## Library Construction Concerns – 4/2/2022

At the March 21, 2022 Library Board meeting, project manager Doug Landry presented the Board with a disc containing the 100% completed construction documents for the new library. The disc documents are in review by Parish Government, the Permits Department, Community Development, and the Fire Marshall. Mr. Landry suggested the Library Board review the documents also. The Library staff also reviewed the documents. The following document highlights several areas that require reconsideration and correction to avoid costly change orders after the bid is advertised and construction begins.

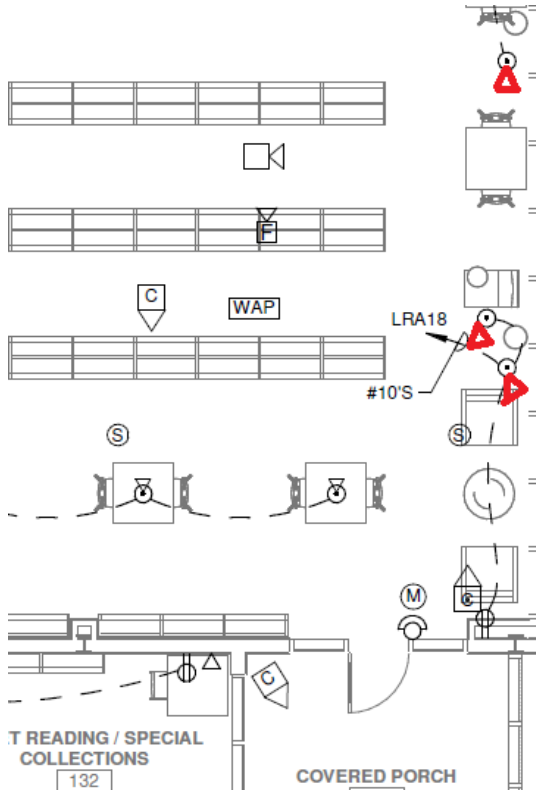
20. **Reading area Ethernet jacks.** Please add the indicated Ethernet jacks in the wall and floor as indicated, as an aid to the patrons using laptops. It is possible we may obtain tables that have built-in Ethernet jacks that will need this feature.

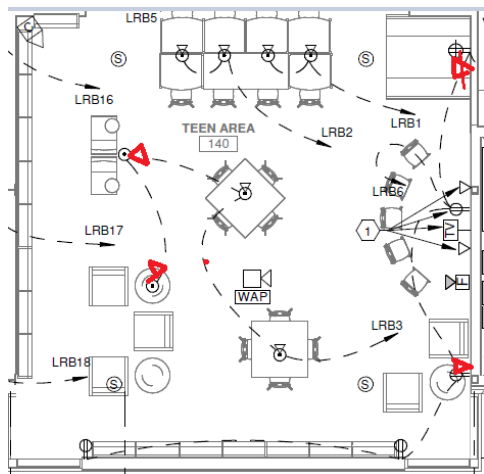
21. **Children's reading area Ethernet jacks.**  
 Similar to the quiet reading area, the children's section needs jacks as shown.

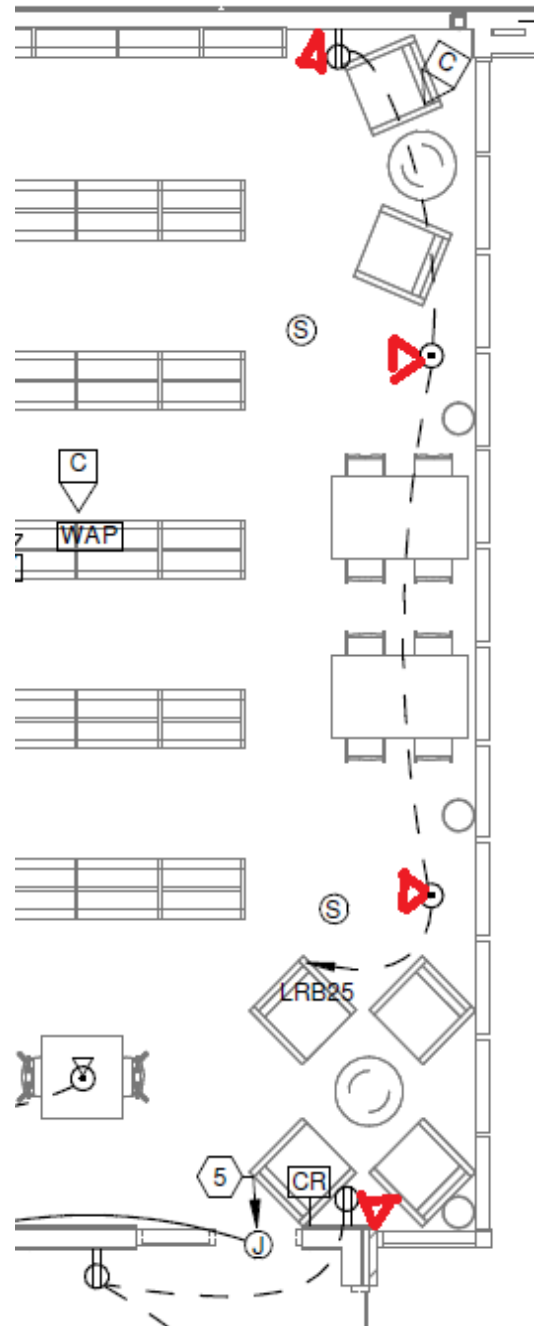
22. **Teen section Ethernet.** Same theory applies where floor outlets are available.

23. **Adult reading area Ethernet jacks.** Also the adult area around the windows needs four jacks located by each electrical outlet.

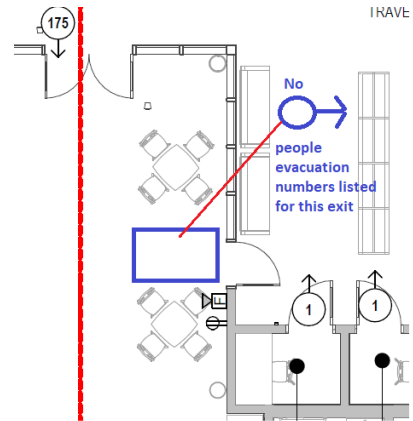
24. **Front lobby changes.** Please add two Ethernet jacks in the vending machine area. These devices are now “smart” and need network access to report on their status (empty/full etc.)

There is an extra lobby door that is still swinging INTO the library instead of OUT of the library as an emergency exit. This current door layout is in question. The public should only be able to enter the library proper through the interior main entrance and be counted for statistics, a requirement by the State Library. At no time should the public be able to enter the library when staff is not on duty.

Civil Blueprint page C101 in error

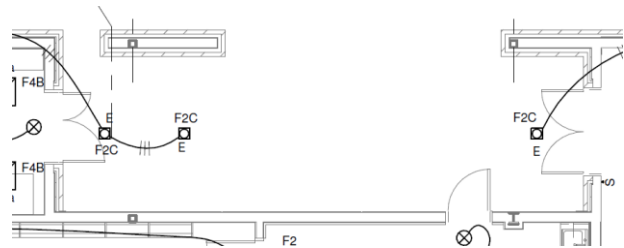
25. **Mistakes in Civil drawing.** On page C101, the outside area at the back of the library where the staff enters shows two extraneous doors, and does NOT show the emergency exit door in the children’s story time area, nor does it indicate the double door entering the staff area, nor the outside wall changes.

Correct diagram (page E101)

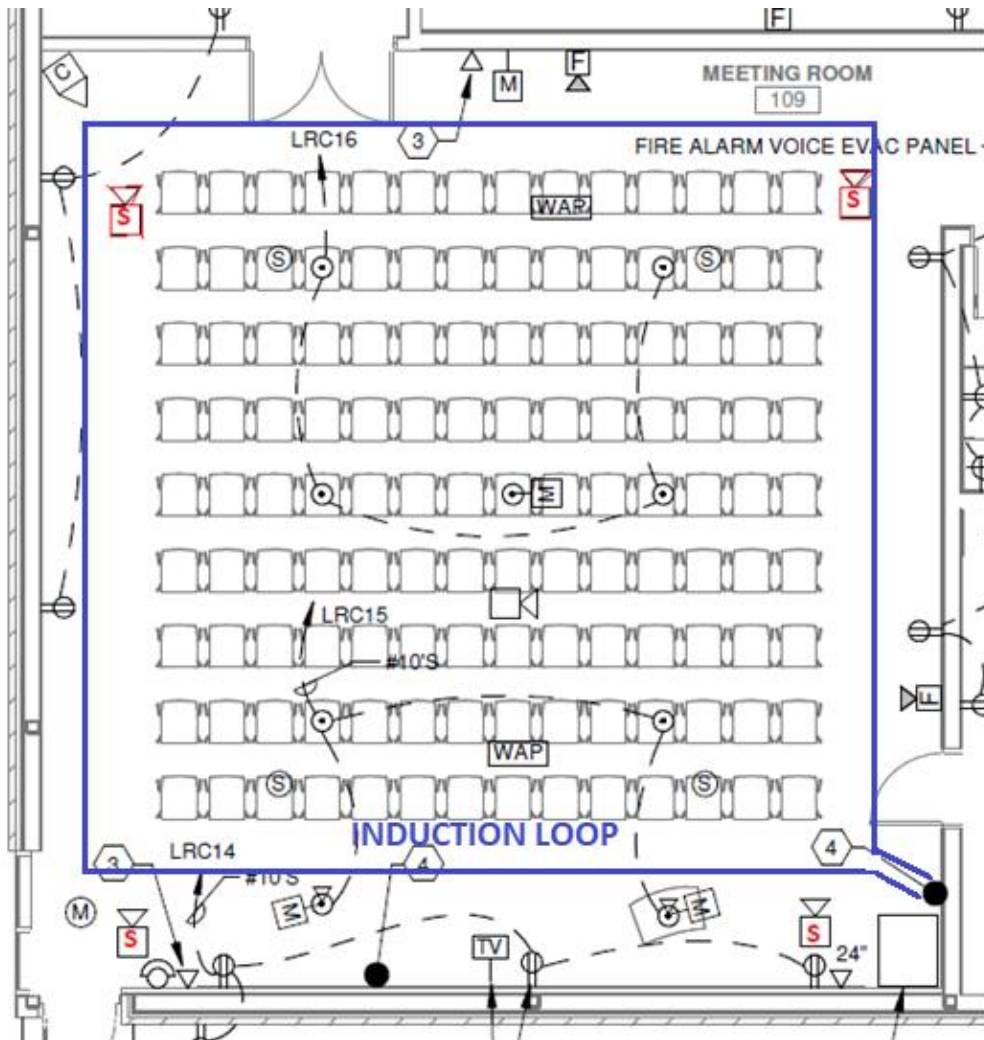
26. **Meeting Room Sound.** There are two front ceiling speakers which are probably mislabeled (*no "S" labeled inside them*), but to insure adequate sound, there probably should be two rear speakers as well. There still will be one ceiling speaker listed in the plan in the center of the room for the library PA announcement system.

Also, we still do not see any ADA-compliant (section 706) sound system available for hearing-impaired listeners for rooms seating more than 50 people (*126 chairs are shown*). The original plans that the staff submitted included a wire channel in the floor or around the walls for a hearing aid induction loop.

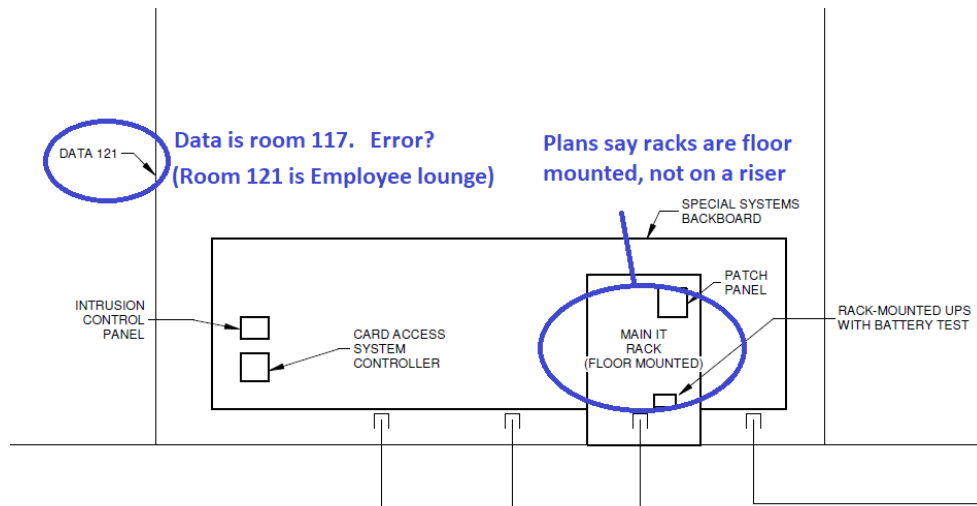
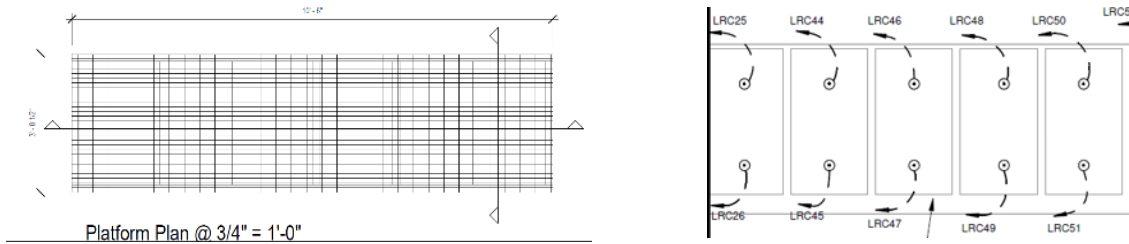
27. **Data room riser.** The existing plans (A131/14) call for a steel grid 10-inch riser system for the equipment racks. There is no place in the design (*left picture*) for mounting the outlets (*right picture*) inside the gridwork. Also, page E101 erroneously states that the racks are floor mounted and uses the wrong room number.

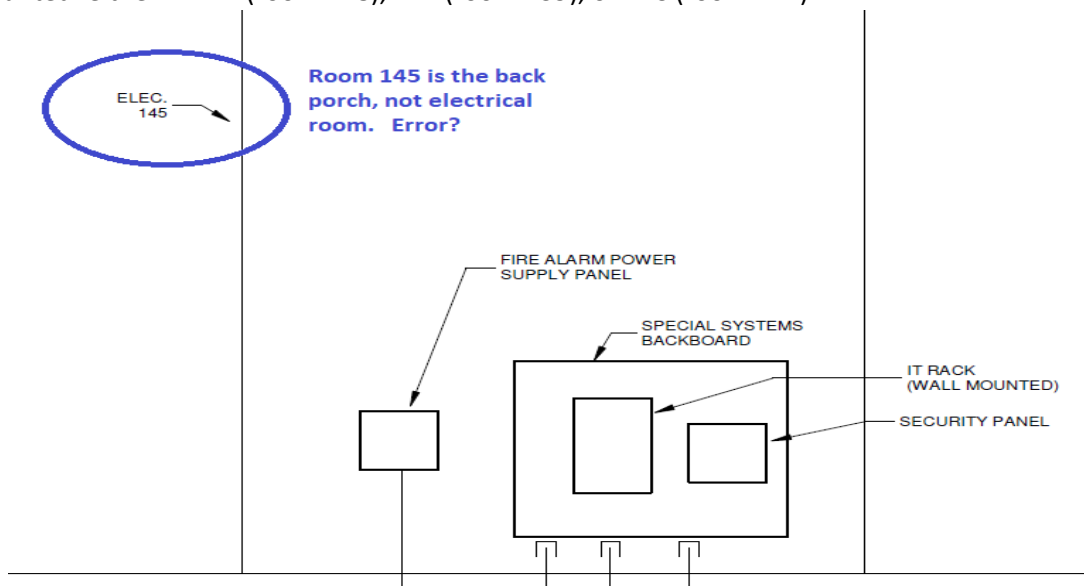
28. **Electrical room mislabeled.** On page A131, it mentions room 145, which is the back porch-- not an electrical room. The other wiring plans make NO reference to where the fire alarm system is to be mounted: either in LRA (room 128), LRB (room 139), or LRC (room 114).

**SE CORNER (Meeting Room)**

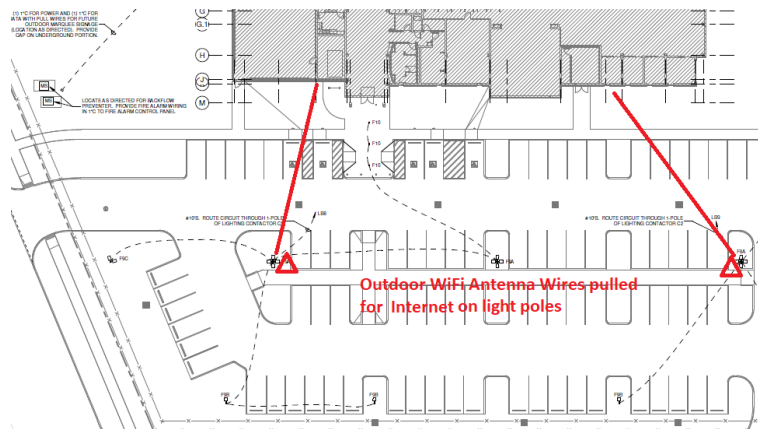
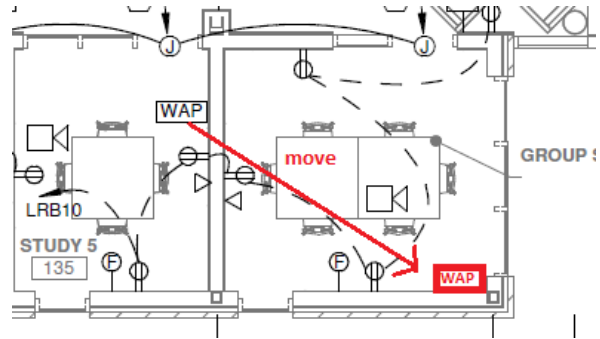
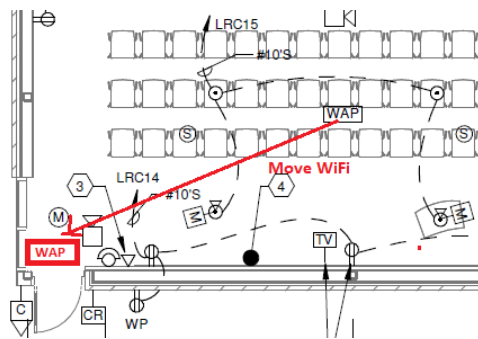
29. **Wireless internet access for parking lot.** Our E-rate requires us to provide access 24 hours a day to the public. Since the staff plan to place outdoor Wi-Fi access points on the outside wall corners was rejected, the next best thing we can do is move the existing ones on the blueprint that are inside the building to as close as possible to the outside walls for patrons to use the internet after hours. Please make the indicated changes to both corner rooms of the building.

Even with this partial solution, the building signal coverage will probably only cover the first row or two of cars. Ideally we should broadcast the Wi-Fi from outside antennas either located at the side of the building or run wires underground to two light poles in the parking lot to provide adequate coverage.

# RTM (Read To Me children's books)

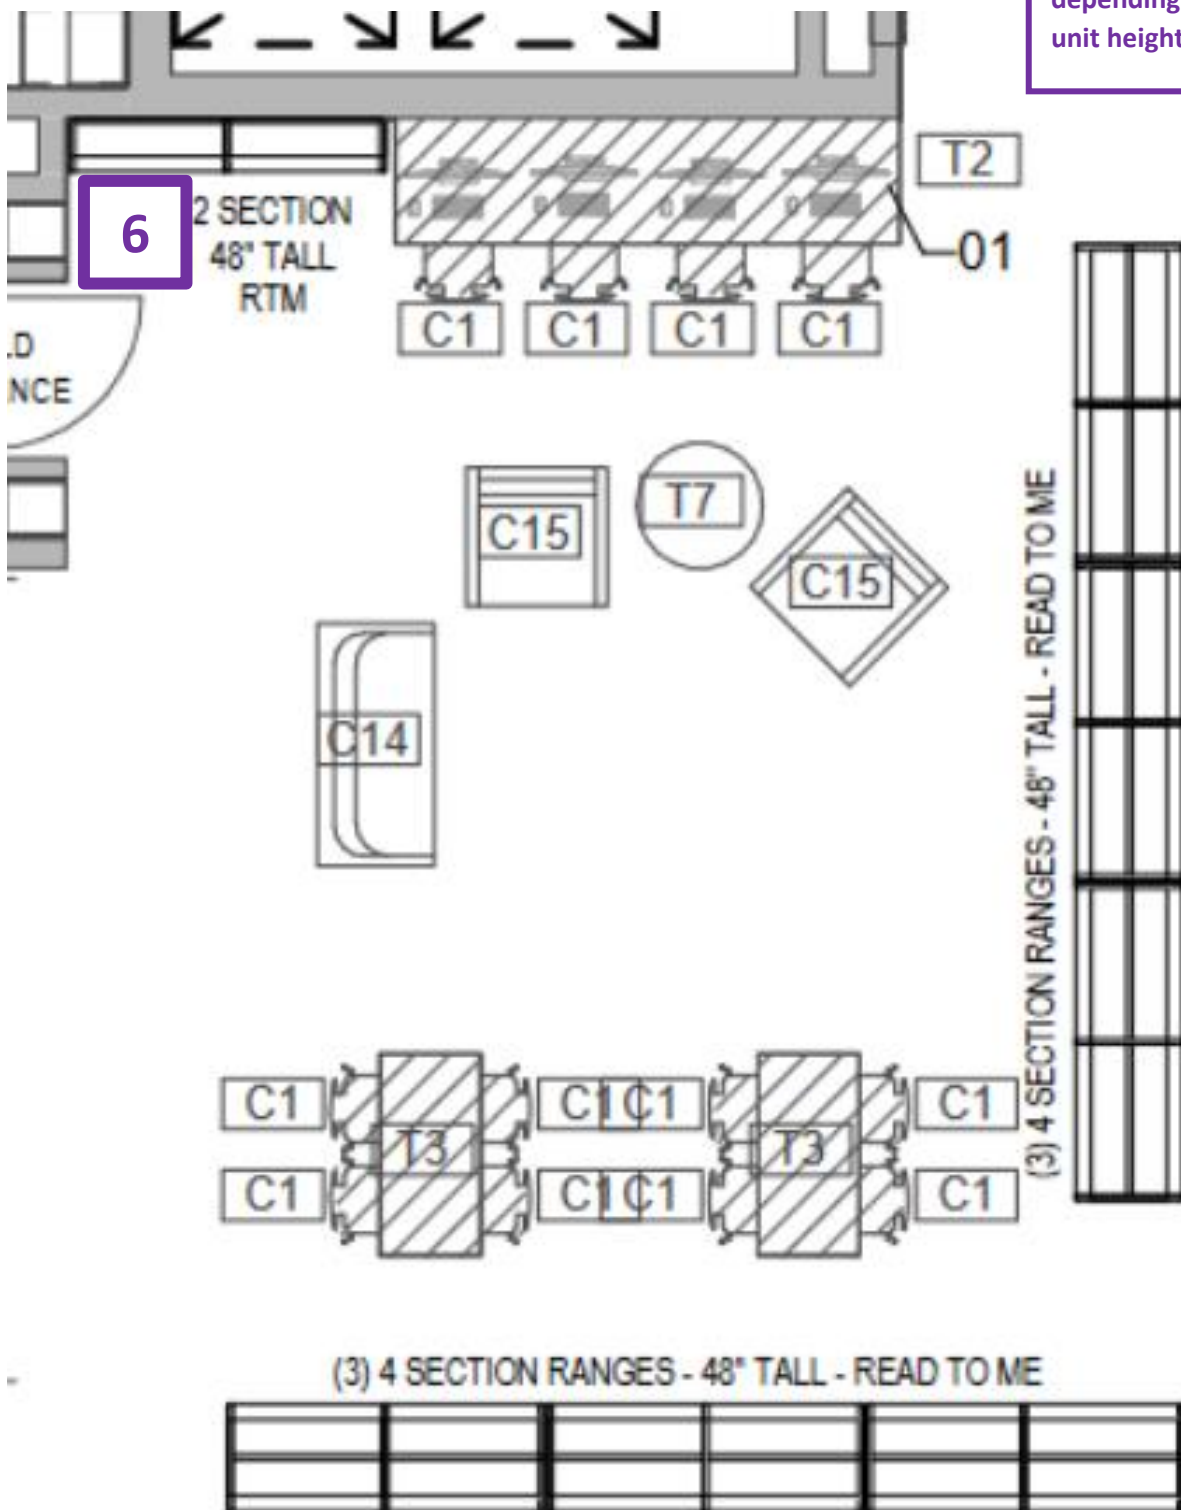
**NO ROOM FOR GROWTH**

**WHY DO WE HAVE 60" SHELVING FOR LTR AND NOT FOR RTM? SAME AGES USE BOTH.**

**CHANGE 48" TO 60" SHELVING UNITS TO GAIN GROWTH SPACE.**

# SNF (Student Non-Fiction books)

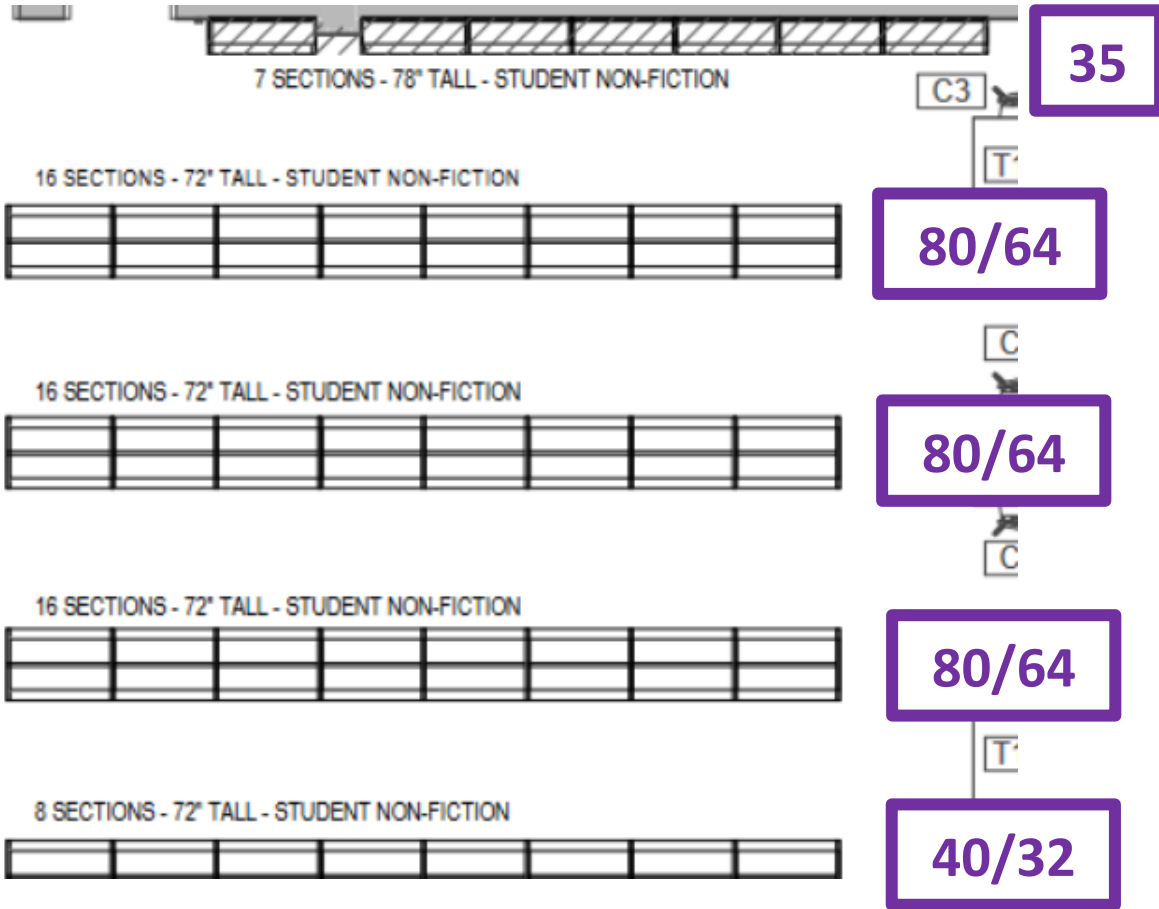
**WE WILL EITHER HAVE NOT ENOUGH ROOM FOR CURRENT COLLECTION IF THE LOWER SHELF COUNT PROVES CORRECT OR VERY LITTLE ROOM FOR GROWTH IN STUDENT NON-FICTION.**

# SF (Student Fiction books)

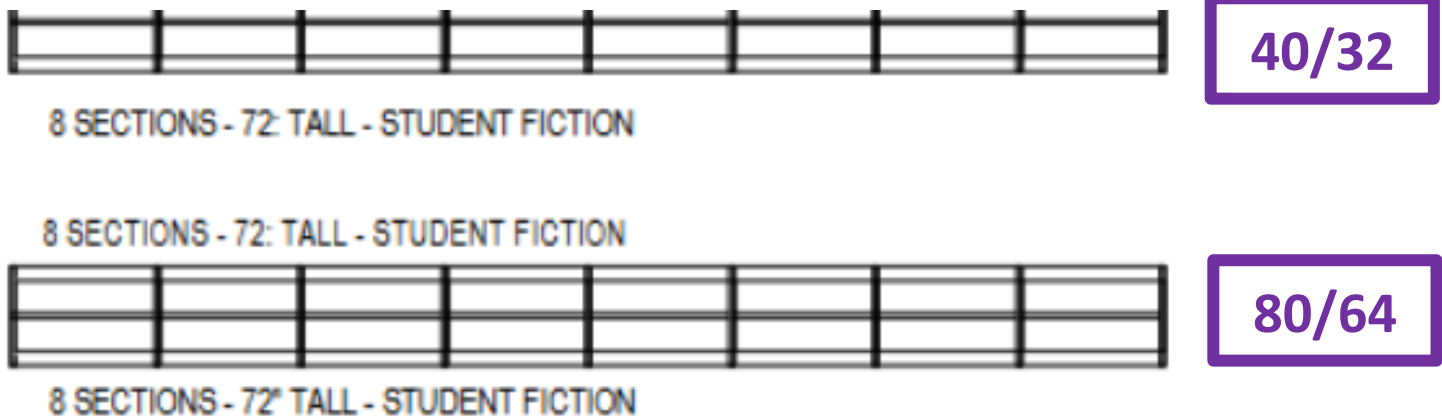
**NEGATIVE SHELF SPACE—CURRENT COLLECTION WILL NOT FIT ON SCHEDULED SHELVING**

# Educational DVDs

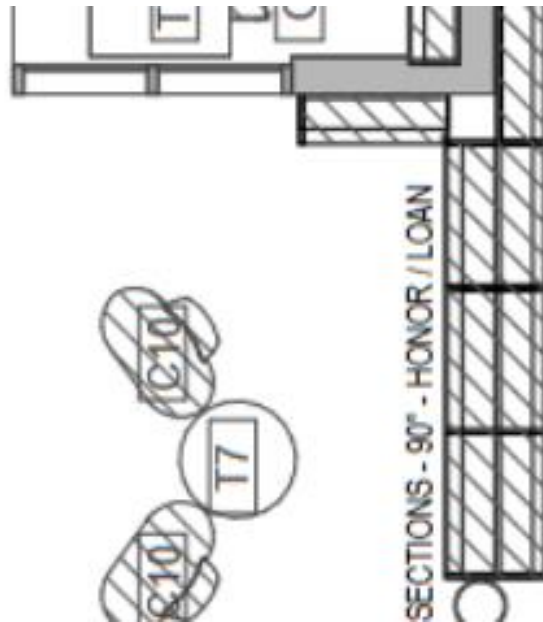
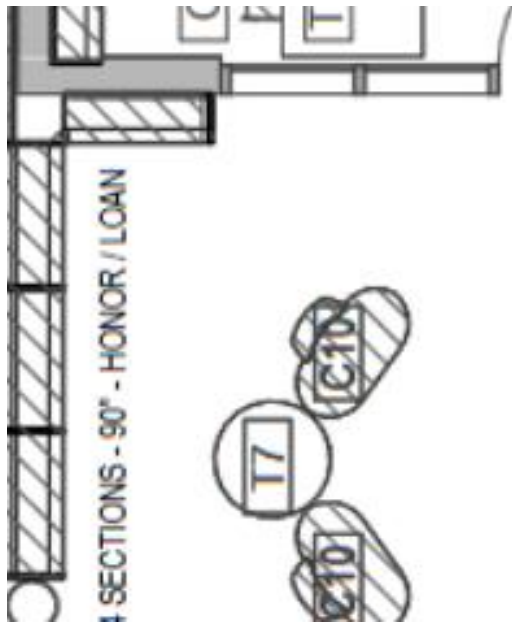
WHY IS THIS DISPROPORTIONATE WITH OTHER OTHER AREAS IN NEED OF GROWTH ROOM?
